Subject: Technical Specification Amendments to Support the Integrated Program for Vessel Flux Reduction and Operation with the New Steam Generators

TURKEY POINT PLANT UNIT NO. 3

Amendment No. 99
License No. DPR-31

SAFETY EVALUATION BY THE OFFICE OF NUCLEAR REACTOR REGULATION
RELATED TO AMENDMENT NO. 99 TO FACILITY OPERATING LICENSE NO. DPR-31
AND AMENDMENT NO. 93 TO FACILITY OPERATING LICENSE NO. DPR-41
FLORIDA POWER AND LIGHT COMPANY
TURKEY POINT PLANT UNIT NOS. 3 AND 4
DOCKET NOS. 50-250 AND 50-251

Figure 2.1-1 Reactor Core Thermal and Hydraulic
Safety Limits, Three Loop Operation

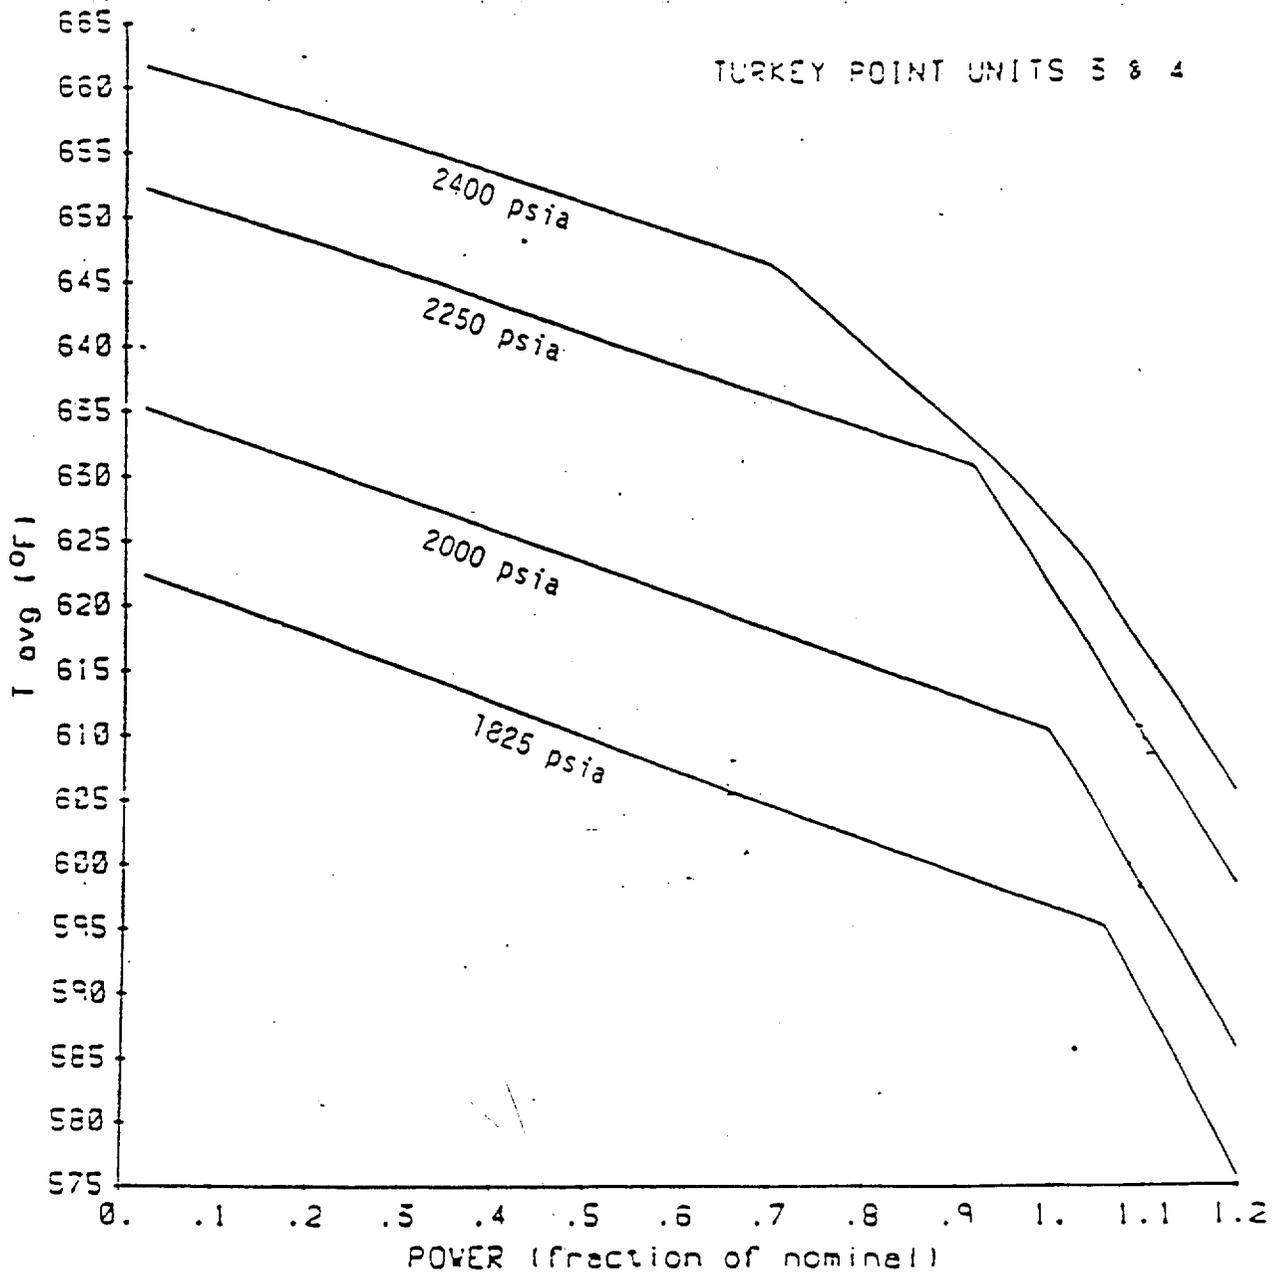
This figure has been modified to remove the "note", which is no longer applicable with the new steam generators.* The limits were recalculated to reflect the increase in the allowable $F_{\Delta H}$ limit, and is acceptable as discussed in Section 4.1.

Plugging level	$[F_Q]_L$	Figure Number for K(Z)
$\leq 5\%$	2.32	3.2-3

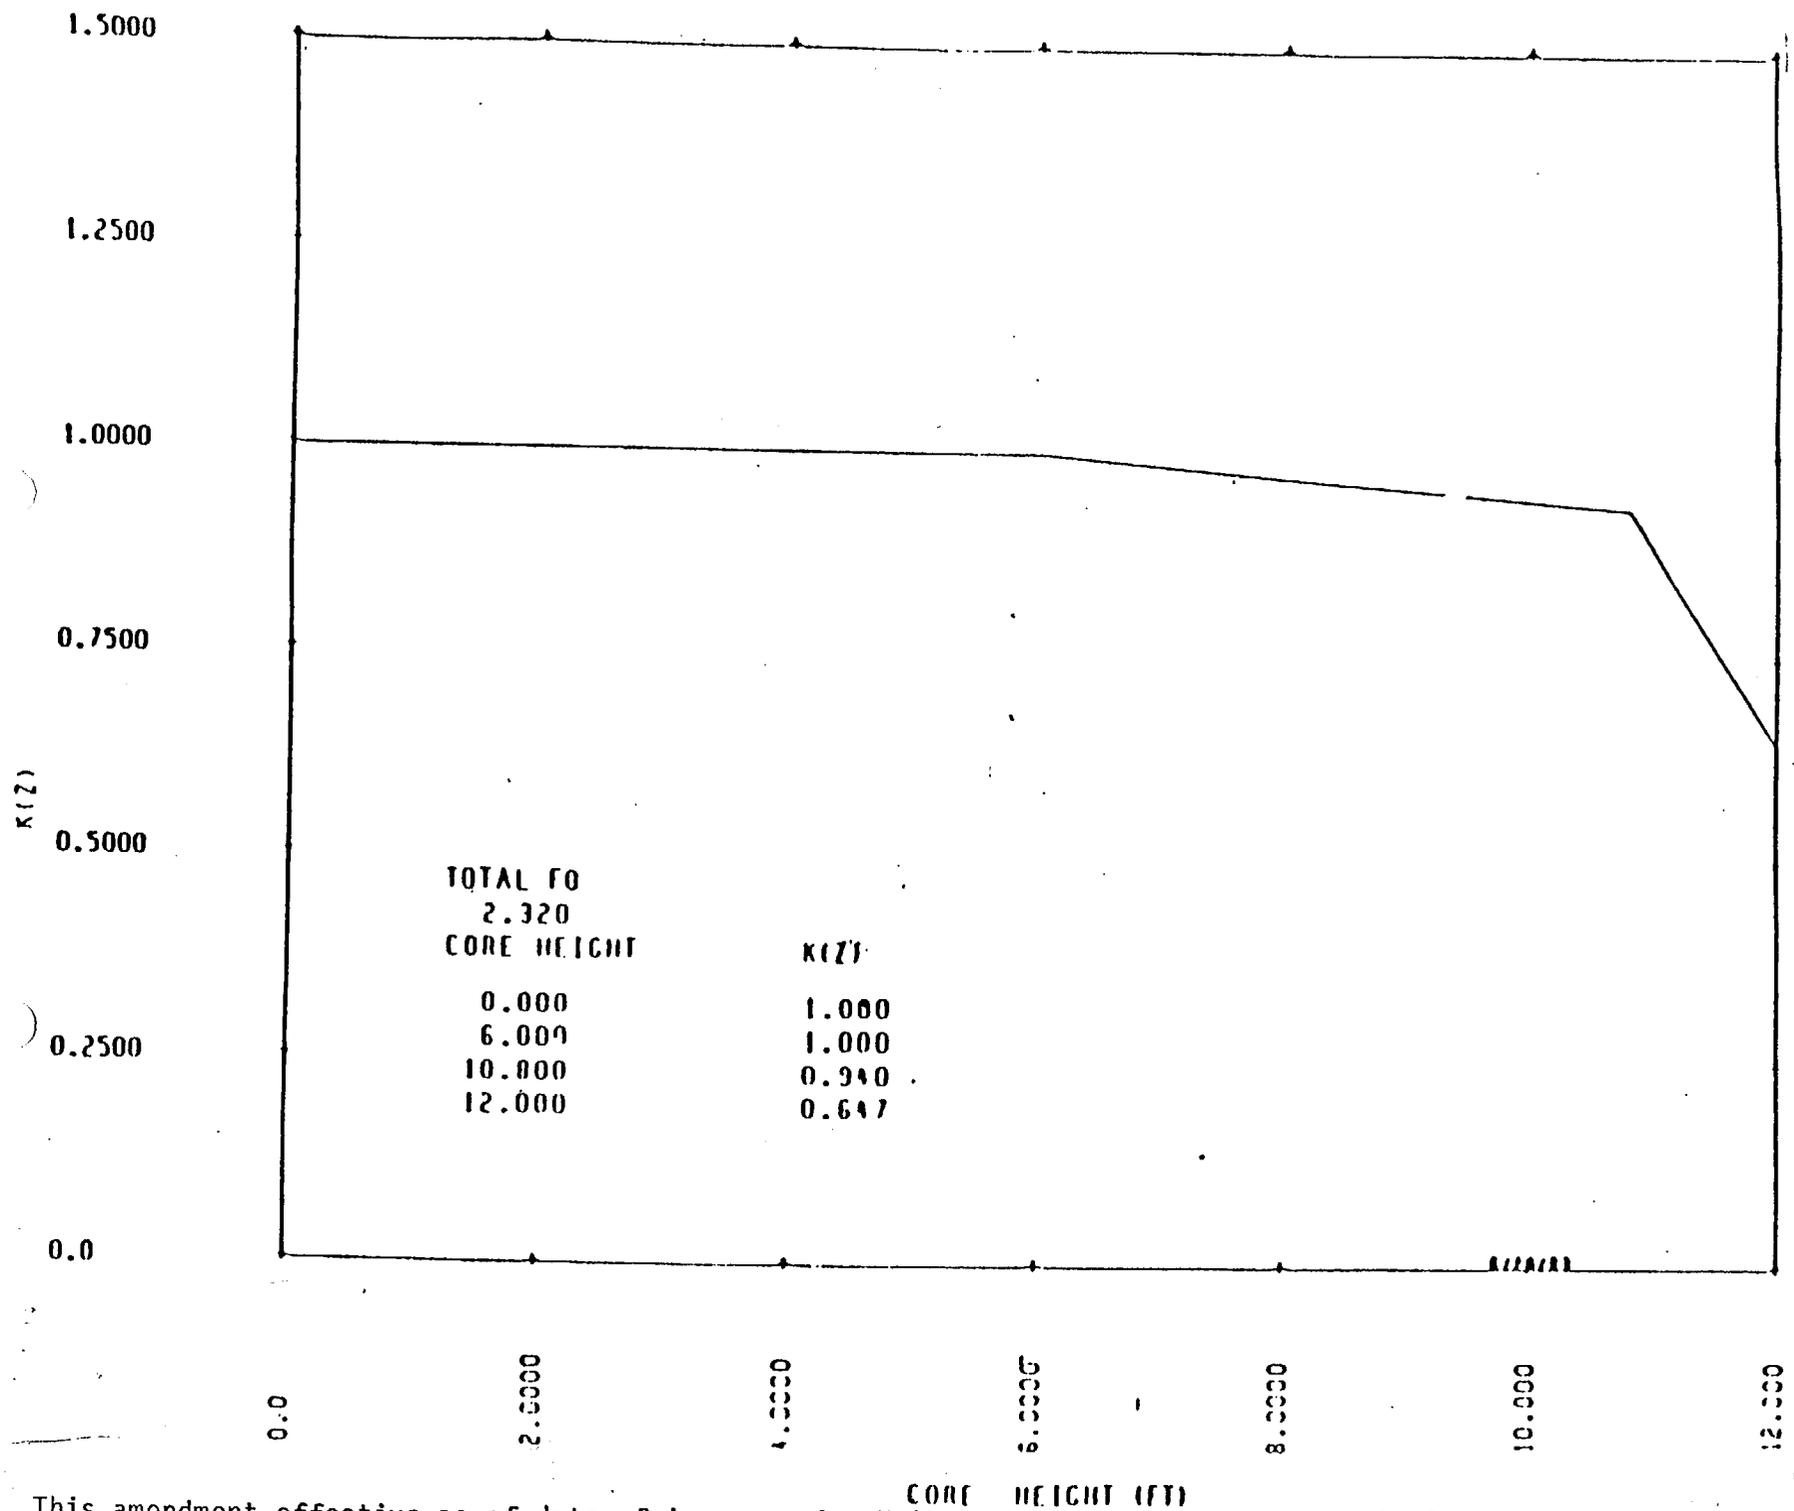
Figure 3.2-3 & 3.2-3a

These figures have been combined into Figure 3.2-3 and revised to present new limits from the LOCA analyses. We calculated this figure independently and agree that it is correct, and therefore this change is acceptable.
